Access Compliance Report

Public Rights-of-Way

Intersection ID: 9211	Main Street: E_SUGAR_CREEK_RD	Cross Street: GREENSBORO_ST	Location: SW
ADA ID: DB3A3157806B	Ramp Type: Perp	Initial Pass/Fail: Pass	Overall Compliance: No
Severity Score: 5			
Codes/Mitigation Info/Possible Solution		Field Measurements/Component Compliance

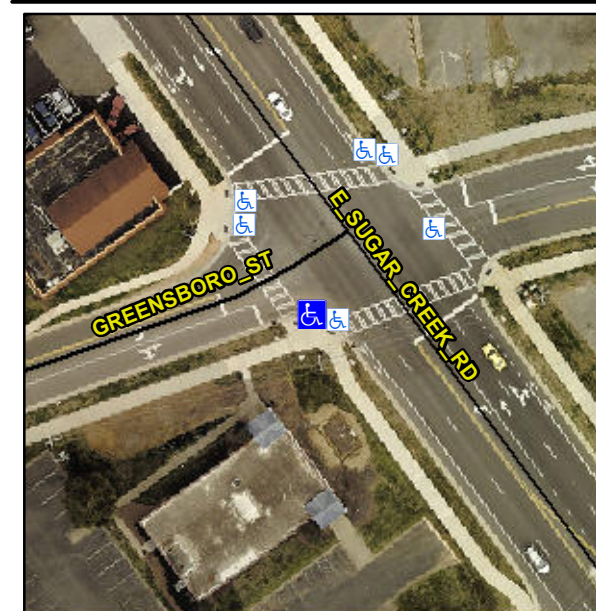
**Not Found, R304.2.3, R305.1.4,
R305.2, R304.5.3**

Compliance	Description	Data	Compliance	Description	Data
N/A	Ramp Length (in)	120.0	Yes	Ramp Slope (%)	5.8
Yes	Ramp Width (in)	53.0	Yes	Ramp XSlope (%)	1.3
N/A	Flare Type LT	Sloped	N/A	Flare Type RT	N/A
N/A	Flare Slope LT (%)	10.5	N/A	Flare Slope RT (%)	3.5
N/A	Flare Traversable LT?	Yes	N/A	Flare Traversable RT?	No
Yes	Landing Length (in)	72.0	Yes	DWS Provided?	Yes
Yes	Landing Width (in)	49.0	Yes	DWS Contrast?	Yes
Yes	Landing Slope (%)	0.6	Yes	DWS Length (in)	24.0
Yes	Landing X Slope (%)	0.5	No	DWS Full Width?	No
N/A	Landing Curb? (Y/N)	No	No	DWS Offset (in)	3.5
N/A	Shared Landing?	No			
Yes	Gutter Ponding?	No	Yes	Gutter Slope (%)	3.0
Yes	Gutter Lip Ht (in)	0.0	No	Gutter X Slope (%)	3.0
N/A	Painted X Walk1?	Yes	N/A	Painted X Walk2?	N/A
	X Walk 1 Direction	To N		X Walk 2 Direction	N/A
N/A	X Walk 1 Width (in)	105.0	N/A	X Walk 2 Width (in)	N/A
	X Walk 1 Slope (%)	0.4		X Walk 2 Slope (%)	N/A
	X Walk 1 X Slope (%)	2.1		X Walk 2 X Slope (%)	N/A

Yes	Ramp inside XWalk1?	Yes	N/A	Ramp inside XWalk2?	N/A
	Road Slope (%)	N/A	N/A	Clear Space?	Yes
	Road X Slope (%)	N/A	N/A	Clear Space to XWalk (in)	N/A
Yes	Any Obstructions?	No	Yes	Storm Grate/Utility Hazard?	No
	Obstruction Type			Storm Grate/Utility Type	
		N/A			N/A
			Yes	Surface Condition? (G/P)	Good

**Remove & Replace Entire Ramp.
Remove & Replace Gutter.**
